UNITED STATES OF AMERICA
NUCLEAR REGULATORY COMMISSION

In the Matter Of)	
)	
EXELON GENERATION COMPANY, LLC,)	Docket No. 50-352-LR
)	Docket No. 50-353-LR
(Limerick Generating Station))

**DECLARATION OF CHRISTOPHER J. WEAVER, Ph.D., ON BEHALF
OF THE NATURAL RESOURCES DEFENSE COUNCIL IN SUPPORT OF MOTION
FOR WAIVER**

8. Figure 1: A chart of the numbers of Initially-Selected or Phase I, and Final or Phase II SAMA candidates analyzed with respect to License Renewal for U.S. BWRs .

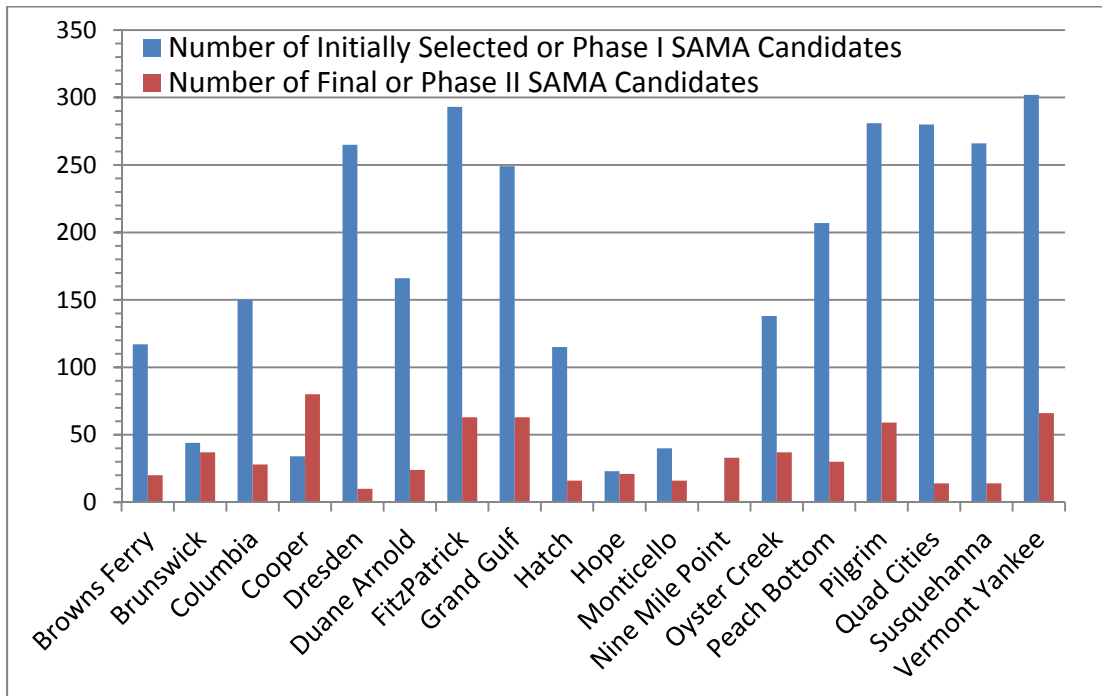
7. (MGM) Subsequent to the 1989 Limerick FES Supplement, industry lessons learned and NRC studies have produced a large set of SAMA candidates that have been analyzed for License Renewal applications in accordance with NEPA. In contrast to the Limerick FES Supplement, the cohort of 27 U.S. BWR units at 18 sites undergoing license renewal reviews, or that have recently been granted license renewal, have on average considered 175 Phase I SAMA candidates and 35 Phase II SAMA candidates (Constellation Energy, 2004; Energy Northwest, 2010; Entergy 2006a; Entergy 2006b; Entergy 2006c; Entergy, 2011; Exelon, 2001; Exelon, 2003a; Exelon, 2003b; Exelon, 2005; Florida Power and Light, 2008; Nebraska Public Power District, 2008; Progress Energy, 2004; PSEG Nuclear, 2009; Southern Nuclear Operating Company, 2000; Susquehanna, 2006;

Tennessee Valley Authority. 2003; Xcel Energy Corporation, 2005). This data is displayed graphically in Figure 1 for these BWR SAMA analyses.

9. (MGM) In my review of these 18 SAMA analyses conducted for BWR License Renewal Applications, the list of initial or Phase I SAMA candidates were developed by applicants both through examining industry documents and by considering plant-specific enhancements. These industry documents were a product of industry lessons learned covering the time period subsequent to the 1989 Limerick FES, and in addition include SAMA candidates from the Individual Plant Examination (IPE) and Individual Plant Examination of External Events (IPEEE) processes. These resources constitute new and significant information post-dating the Limerick FES Supplement. Limerick is unique in that it alone, among all the BWR's seeking or obtaining license renewal, has not conducted a systematic consideration of the cost and benefits of these additional mitigation alternatives,

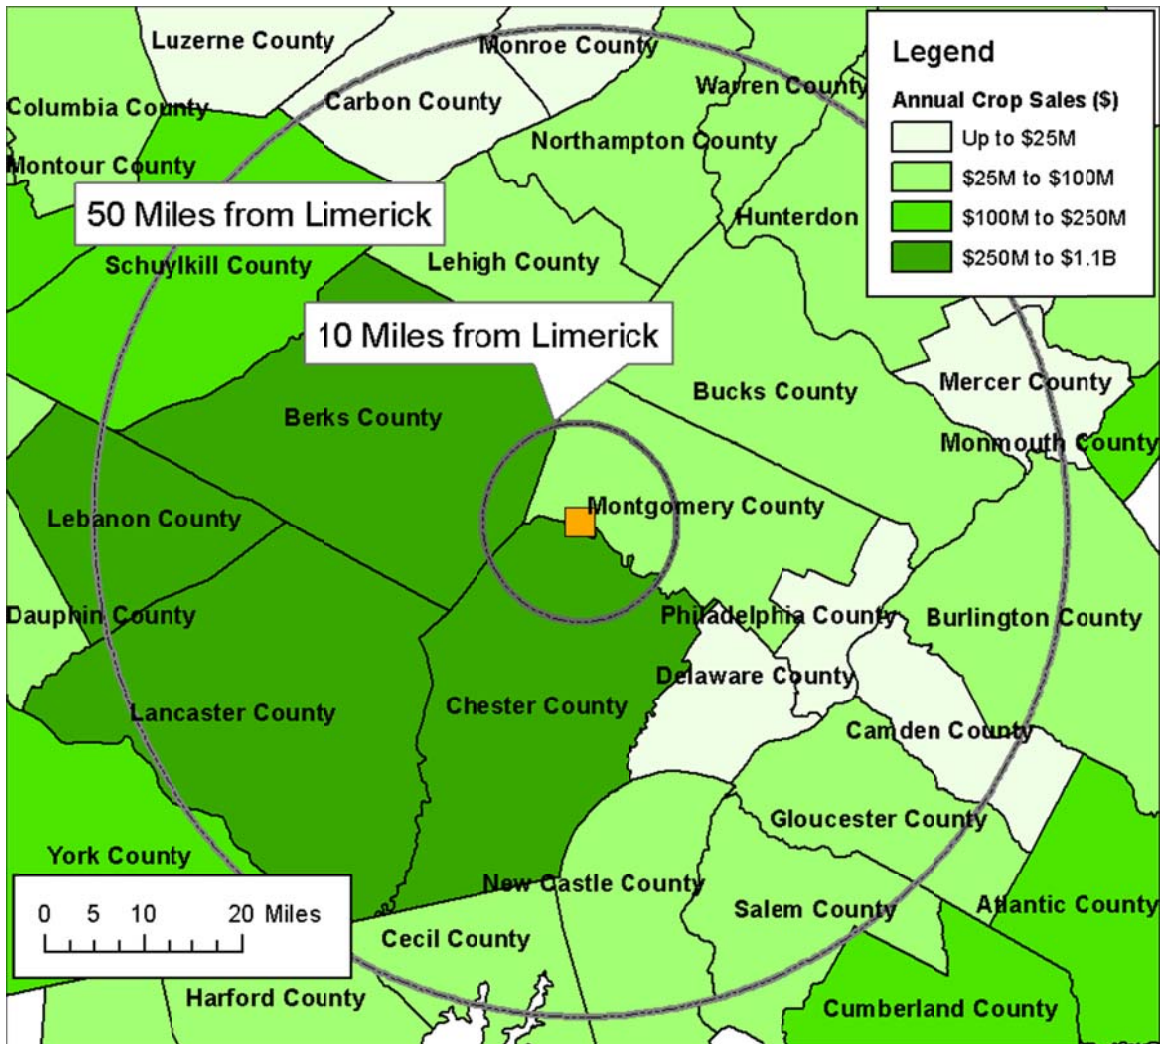
23. (MGM) Agriculture is an important component to the economic risk to the west of Limerick has. As an example of data pertinent to determining economic risk that is absent from the Limerick FES Supplement but found universally in SAMA analyses conducted for other BWR License Renewal Applications, I have displayed U.S. Bureau of Agriculture statistics on crop sales by county within the 50-mile zone around Limerick in Figure 2 (USDA, 2011). As can be seen in this figure, Lancaster County to the southwest of Limerick had over \$1 billion in crop sales in 2007, Chester Counties had about one-half billion dollars in crop sales in 2007, and Berks County had about \$400 million in crops sales in 2007 (USDA, 2011).
24. (MGM) Figure 2: US Bureau of Agriculture data on annual crop sales in the area surrounding Limerick in 2007 (USDA, 2011).
